Office Action Summary

10/518,194

NOMURA ET AL.

As shown in Fig. 1 of JP '492, water and an electrolytic solution are selectively jettted from nozzles **12, 13** on the rolls **2**:

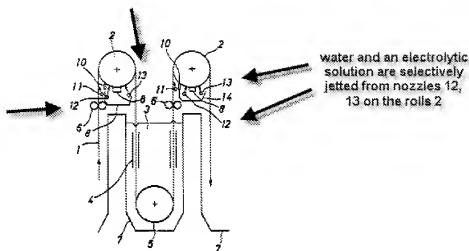
By the positions of the nozzles **12, 13**, it appears that the jetted electrolytic solution would have been attracted to the surface of the conductor roll **1** and provided a thin film of electrolytic solution between the surface of the roll and the metallic strip **1** to some degree.
